STAFF RECOMMENDATION

**405 Broadway
June 16, 2021**

Application: New Construction—Infill
District: Broadway Historic Preservation Zoning Overlay
Council District: 19
Base Zoning: DTC
Map and Parcel Number: 09306410900
Applicant: Gina Emmanuel, Centric Architecture
Project Lead: Melissa Baldock, melissa.baldock@nashville.gov

Figure 3 (right) some of the architectural elements of the façade turn the corner. Figure 4 (left) shows how in the 1970s, the structure next door obscured or eradicated the portions of the storefront details that turned the corner. The column and storefront details were restored in the late 1980s.

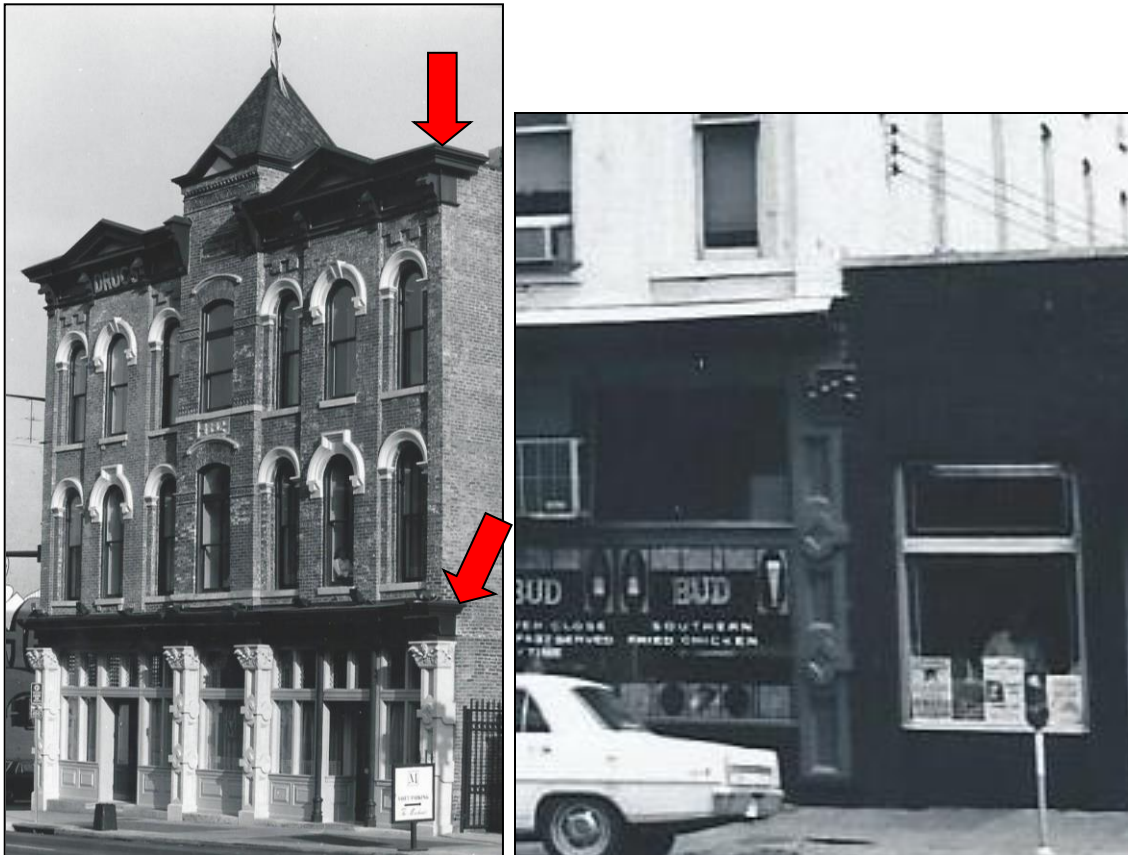
The infill is designed to extend the entire width of the lots along both Broadway and 4th Avenue South. That meets the historic context along 4th Avenue North. However, along Broadway, the historic top cornice and storefront cornice and column turn the corner of the building and extend into the area of 405 Broadway (Figure 3). The design of 405 Broadway does not currently accommodate these historic features and seems to require their partial removal.

The ground floor storefront elements are restored elements from the 1980s. Previously, a one-story mid-twentieth century structure covered these features (Figures 4-5). Staff was unable to find early photographs of the structure confirming that the storefront cornice and column did extend into some of the side façade. However, an 1897 Sanborn map, which dates to just a few years after 401-403 Broadway was constructed, shows clearly that there was a small gap between 401-403 Broadway and the one-story store next door (Figure 6). This allowed 401-403 Broadway to have the side windows with metal shutters and also allowed for the front façade architectural elements to turn the corner. Staff therefore finds that the storefront column and cornice likely did turn the corner and that the 1980s restoration of the building restored this historic feature.

Because these elements on 401 Broadway are restorations of historic conditions, their partial demolition does not meet the design guidelines. Staff recommends that the design of the infill along Broadway be revised so that the architectural features on 401 Broadway are not altered.

With the condition that the infill design allow the storefront cornice and column and the top cornice at 401 Broadway to remain unaltered, Staff finds that the infill's height and scale to meet Sections III.A. and III.B. of the Broadway design guidelines.

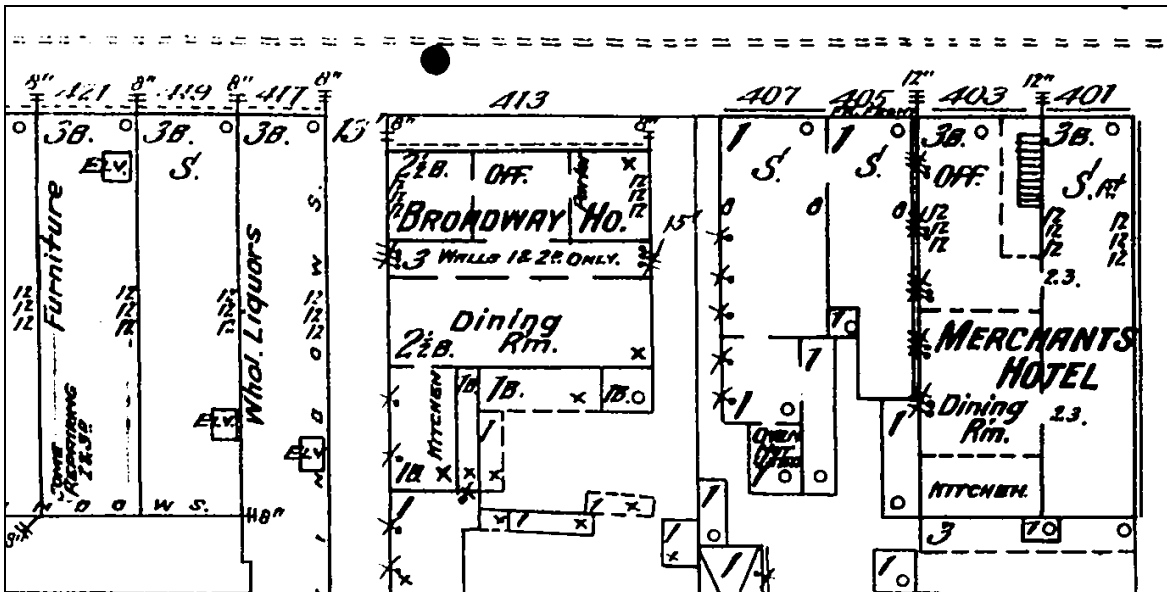
Figure 6. The c.1897 Sanborn map was published just a few years after 401 Broadway was constructed. It shows a gap between 401-403 Broadway and the one-story structure at 405 Broadway. The 12" mark on the map indicates the number of inches above the roof the firewall extends and not the width of the gap, but it is clear there was a gap between the two structures, allowing the architectural elements to turn the corner.

BROADWAY ELEVATION

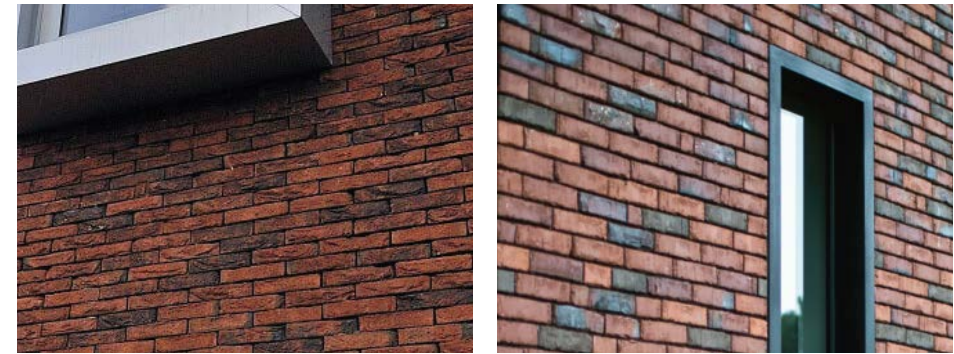
However, staff finds that the proposed central, two-story arches on both facades do not meet the guidelines in terms of proportion and rhythm of openings. Two-story arched window openings are not found historically in the Broadway Historic Preservation Zoning Overlay. Moreover, the design feature skews the proportion of openings on the lower three facades. Rather than the window openings on the lower floors being taller than those above, the arches skew the proportions, making the second floors seem taller than the first floors. Staff recommends that the arches be removed and the second floor central bays have punched window openings like the third stories.

With the condition that the central, two-story arches be removed and the second floor central bays have punched window openings like the third stories, staff finds that the infill’s proportion and rhythm of openings to meet Section III.E. of the Broadway design guidelines.

4TH AVENUE ELEVATION

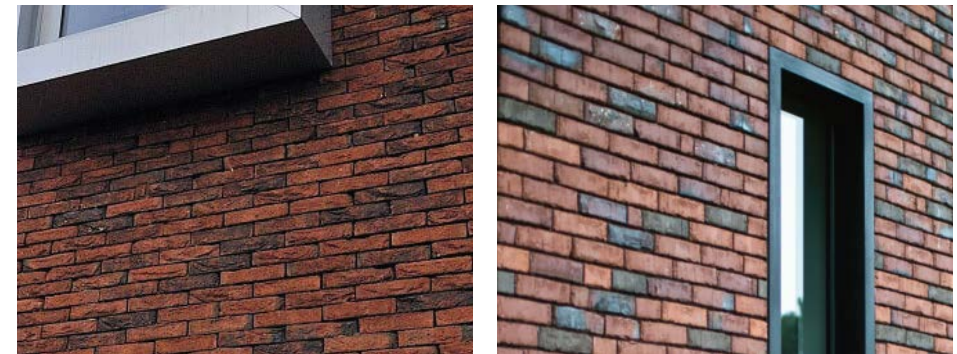
Proportion and Rhythm of Openings: The storefront on Broadway is almost entirely glass, which meets the design guidelines. The storefront on 4th Avenue South has approximately one-third of it devoted to a recessed, non-transparent service area. Staff finds that this is an appropriate location for a needed service area for the building since Broadway is the primary façade.
